S E R V I C E N O T E

6015A Autoranging DC Power Supply

Modification using RTV to prevent W8 Ribbon Cable disconnect.**Duplicate Service Notes:**

Figure 1

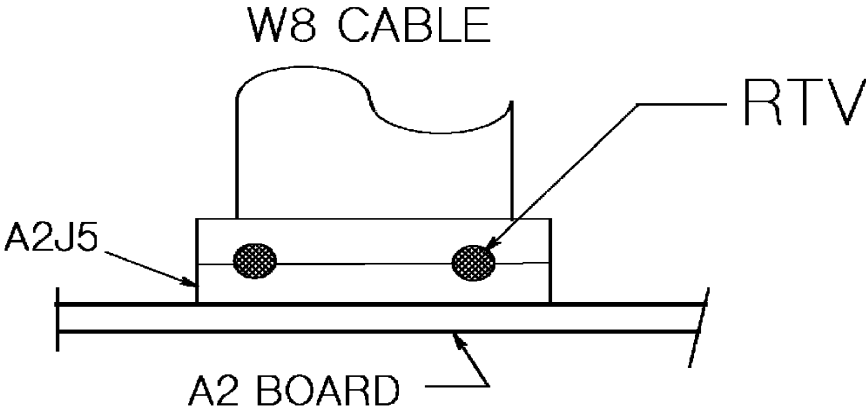
The W8 ribbon cable connecting the A1 main board assembly to the A2 Control board assembly may vibrate loose during transportation. This only involves units with serial numbers inclusive of those listed above.

Reconnect the W8 ribbon cable. Use RTV to secure the W8 connector to the J5 mating connector on the A2 assembly. Put a 8 mm (0.313 in) size spot bridging the W8 / J5 connectors. Bridge the connectors with an RTV spot at each end as shown in figure 1.
